SUNSET VILLAGE FILING NO. 4

CONSTRUCTION PLANS

**CONSTRUCTION DRAWINGS AMENDMENT,
DATED APRIL 4, 2026 BY ENGINEERING LOCAL
XPRTS, LLC.**

REVISION 1: 01/07/2022
COR218 REVISION 2 (ELX
JULY 2026)

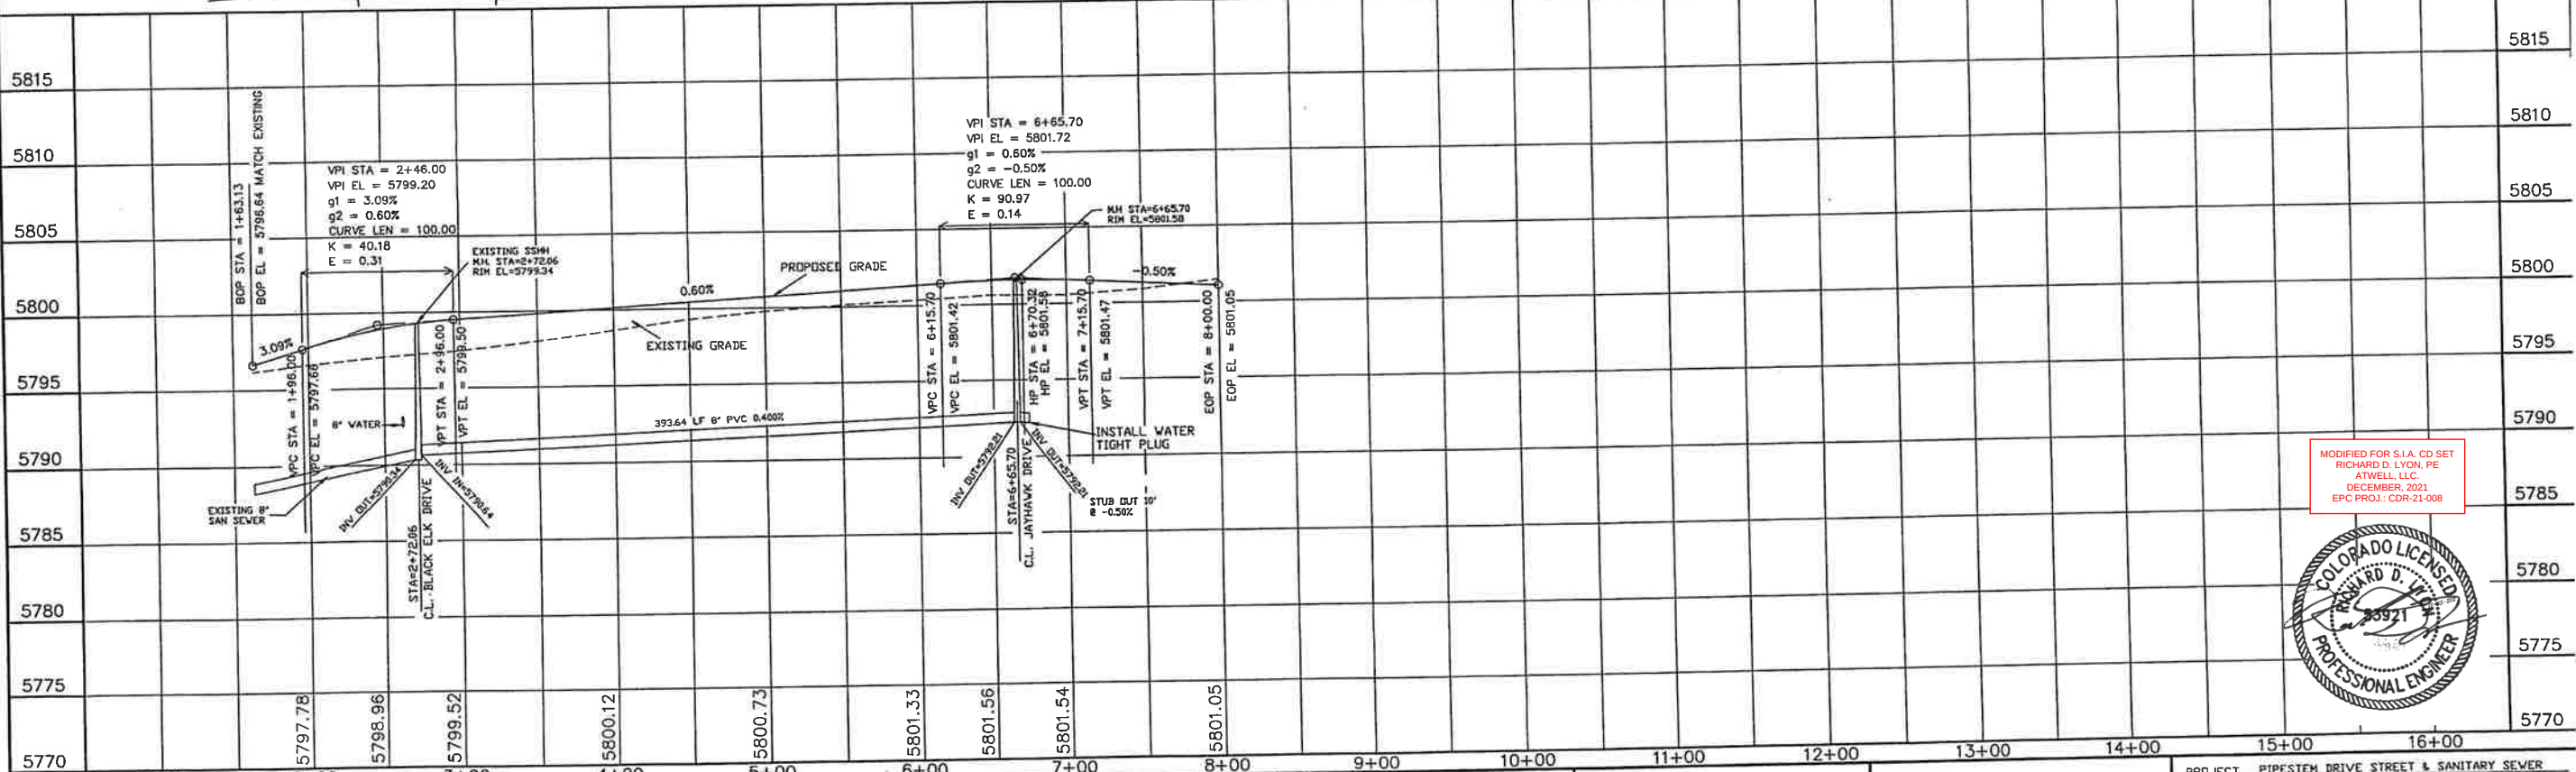
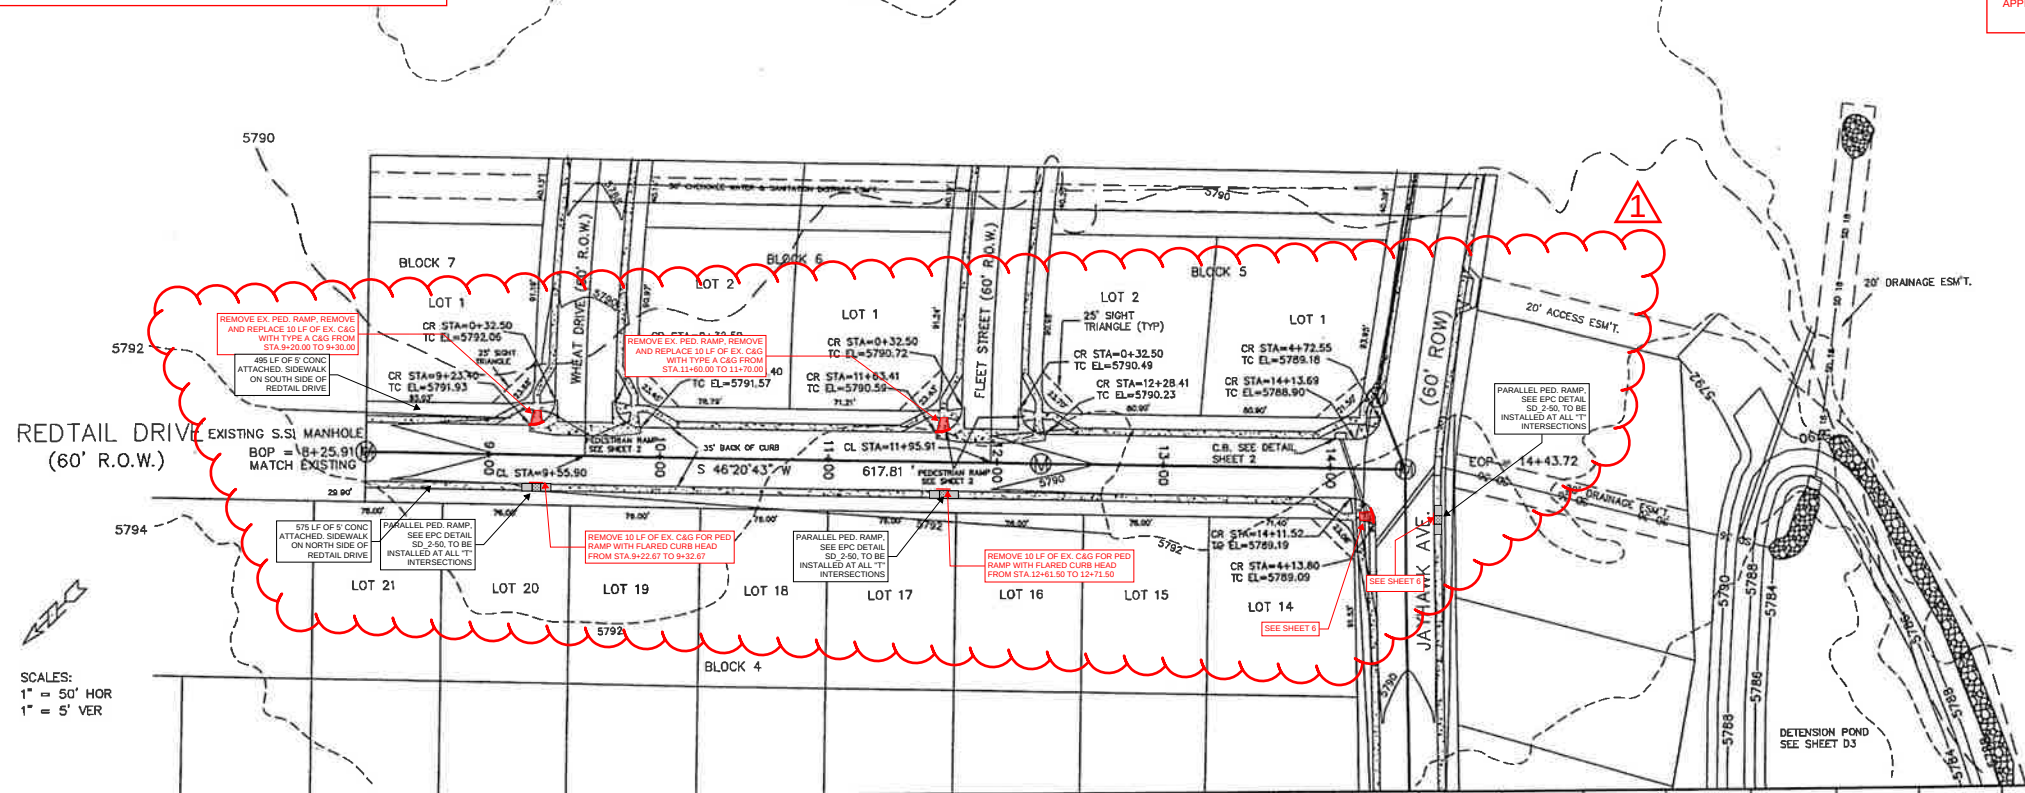
* CURB AND GUTTER MARKED IN THE FIELD TO BE REPLACED IN-KIND. ESTIMATED TO BE APPROXIMATELY 900 LF IN TOTAL.

* CURB AND GUTTER MARKED IN THE FIELD TO BE REPLACED IN-KIND. ESTIMATED TO BE APPROXIMATELY 900 LF IN TOTAL.

SHEET TITLE:
FOREBAY DETAILS

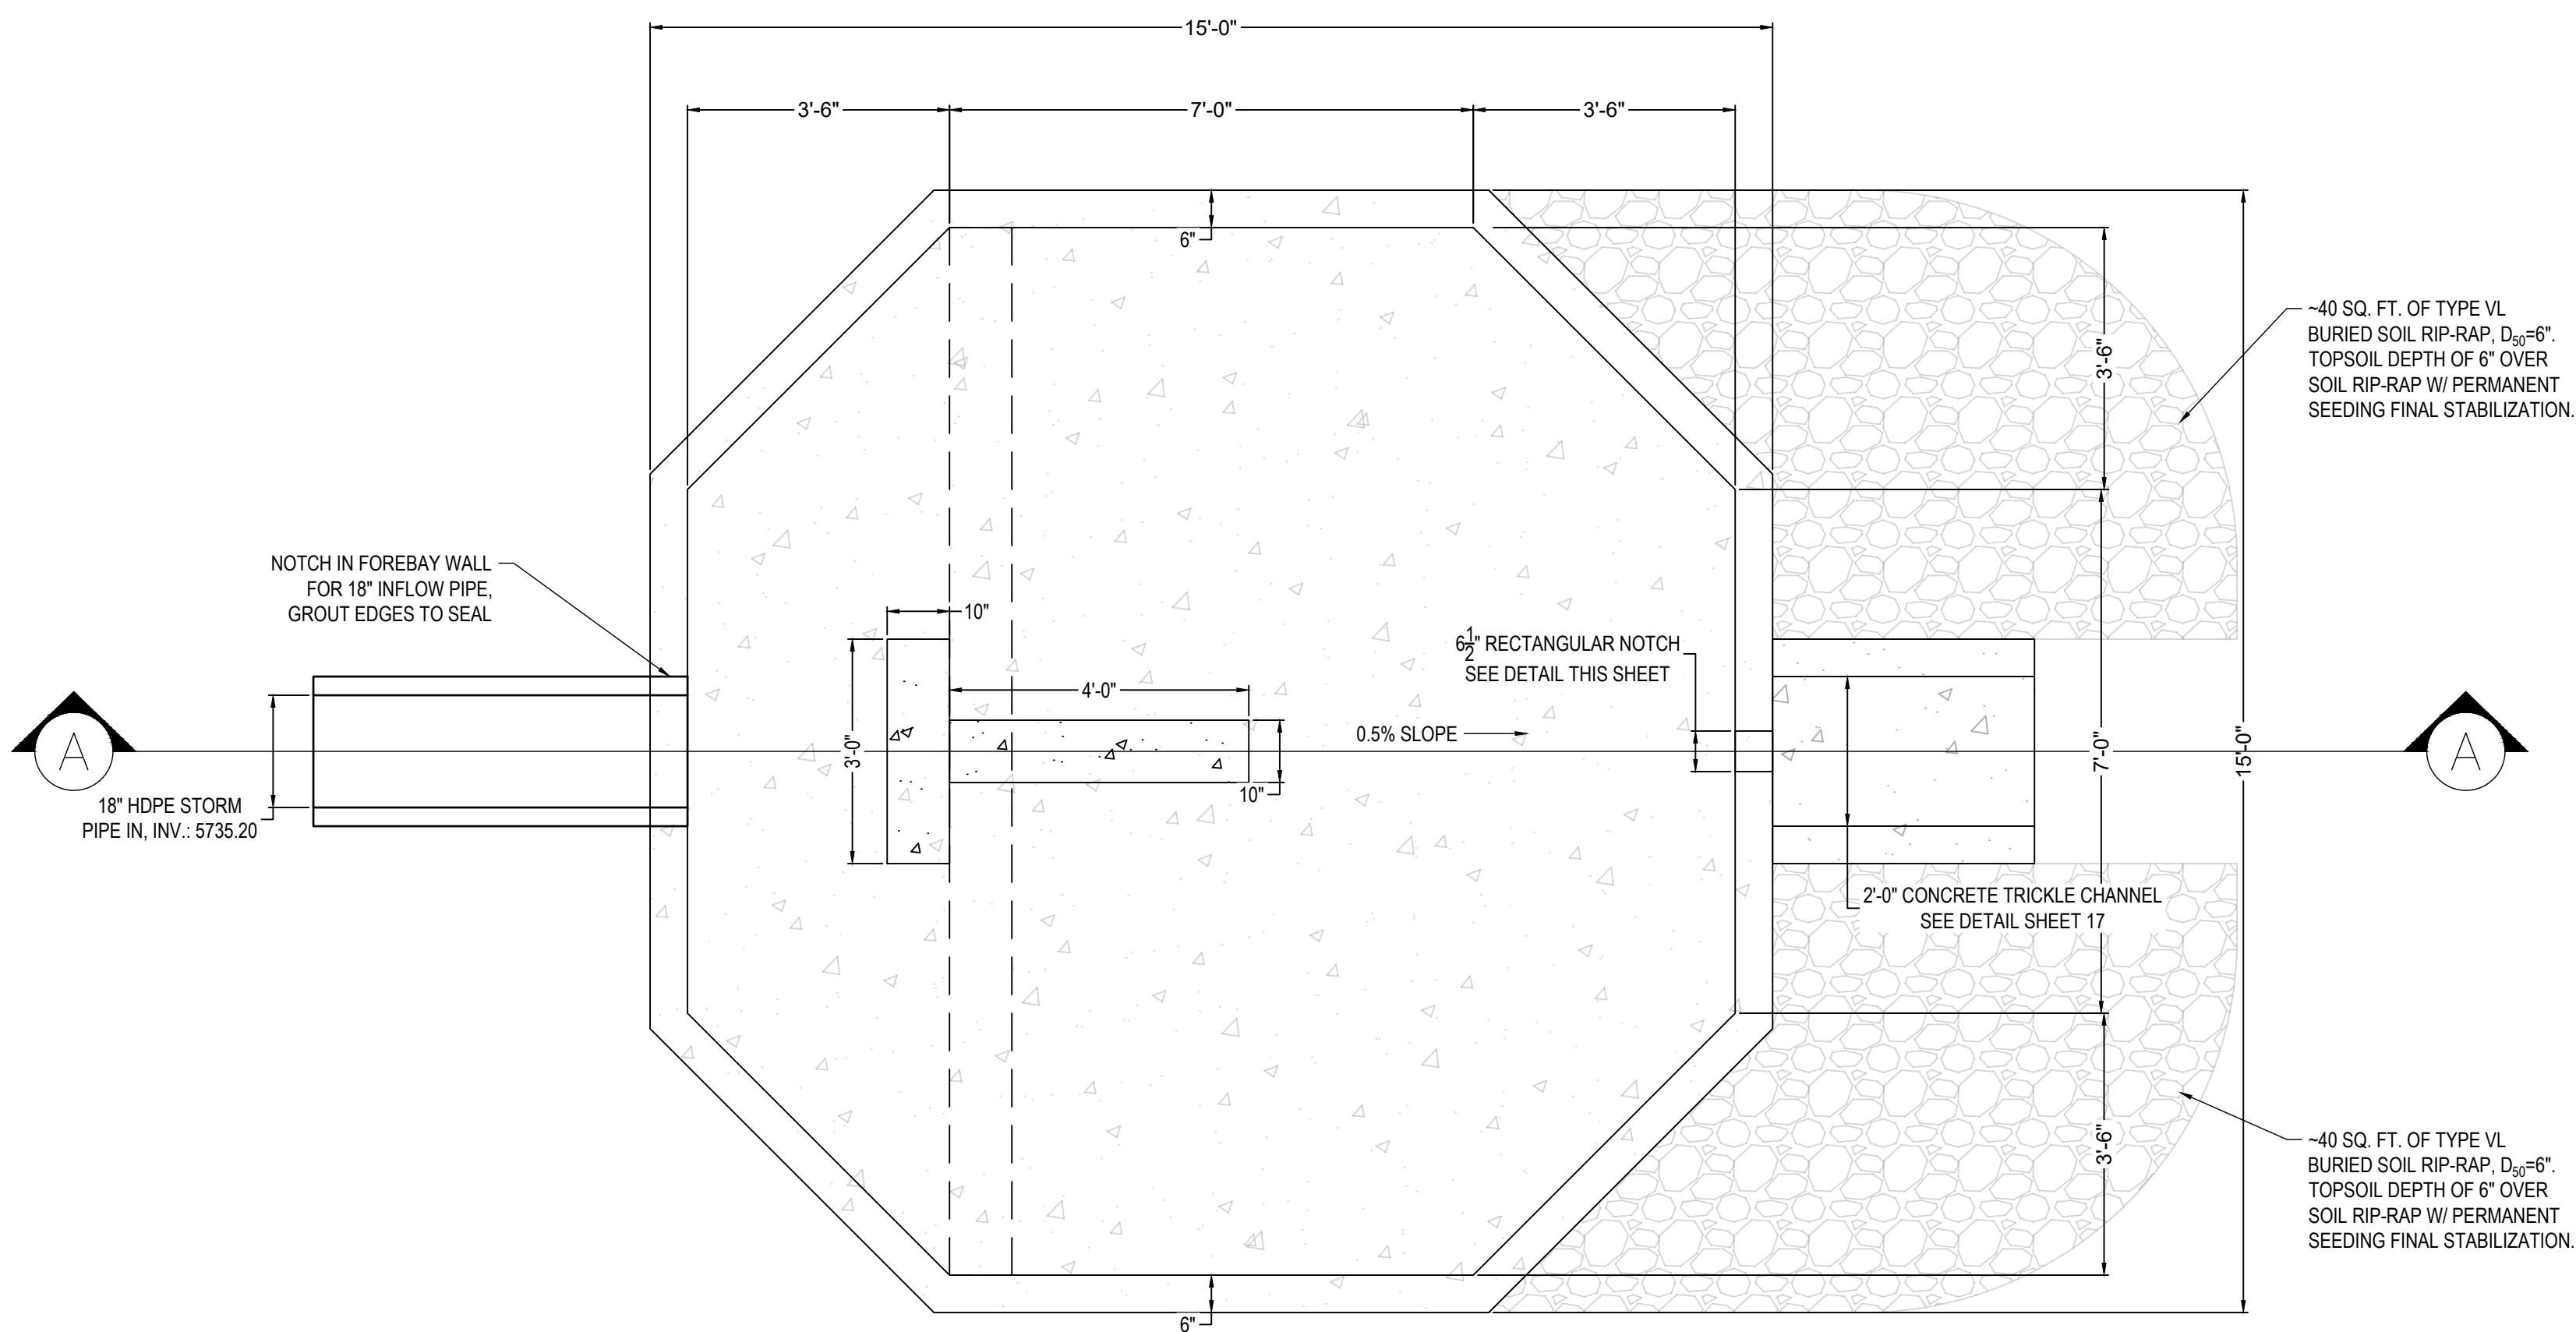
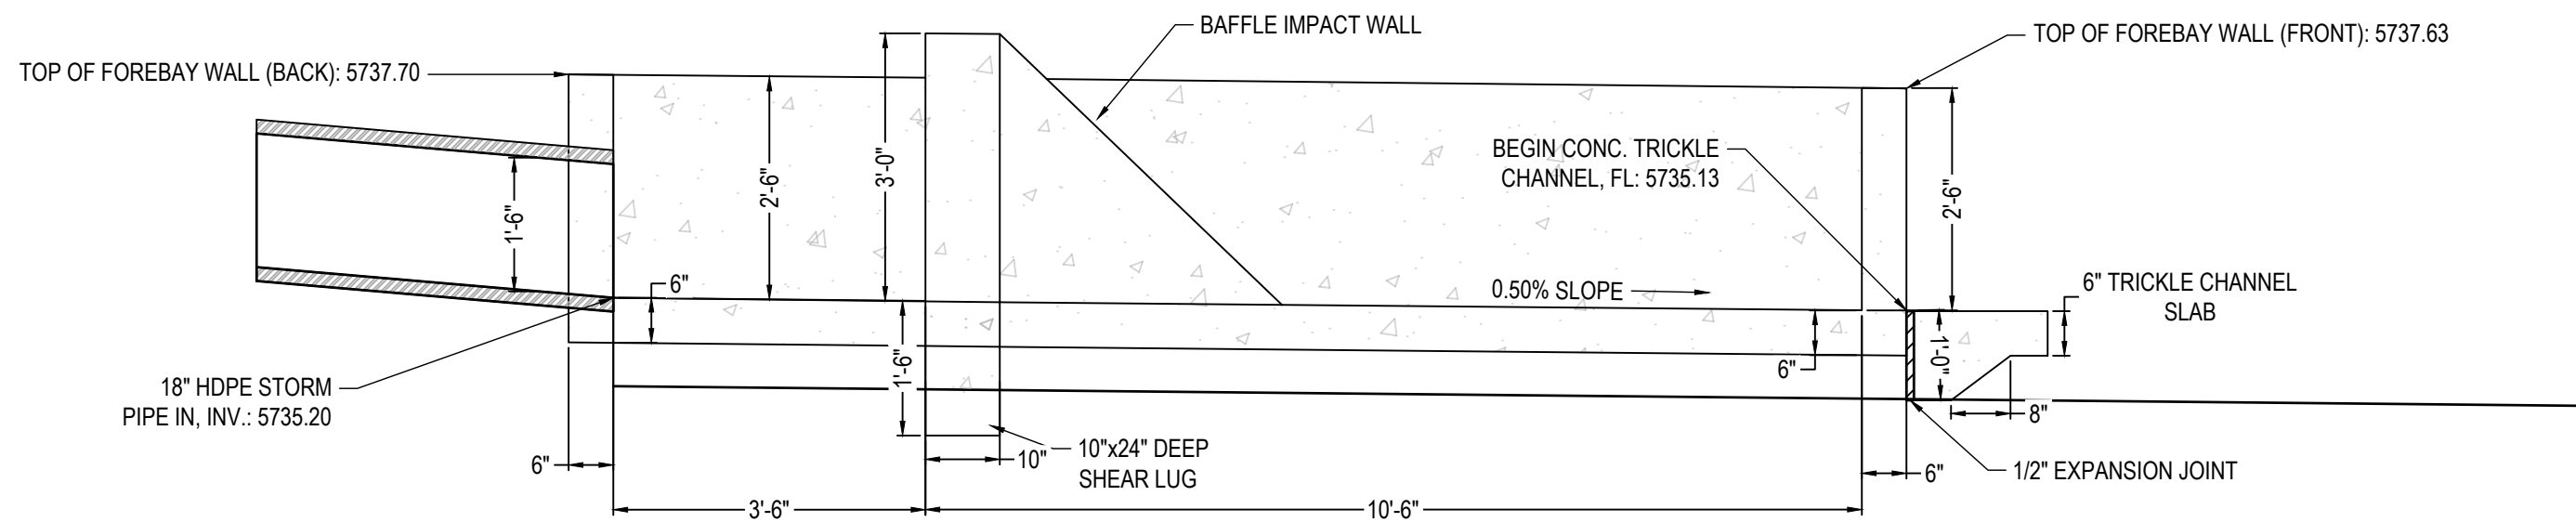
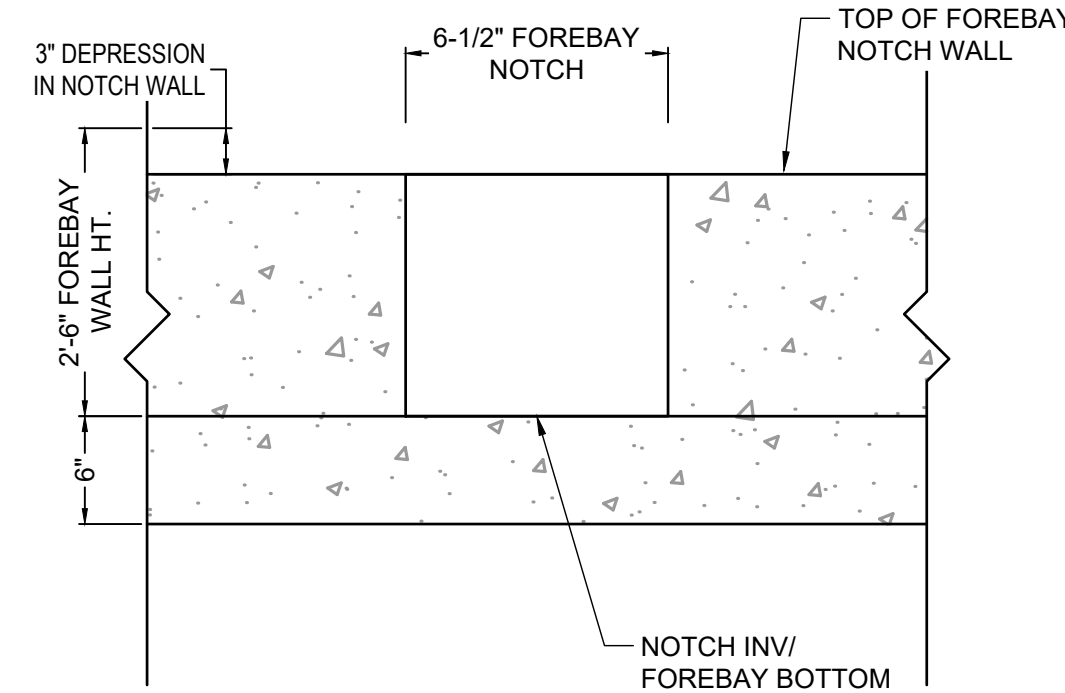
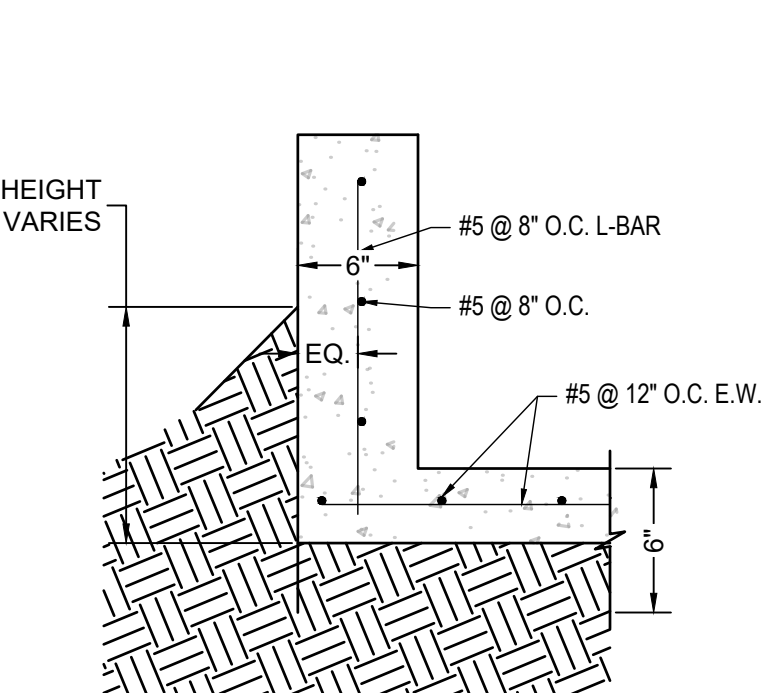
09/22/2026
ELX REVISION #2
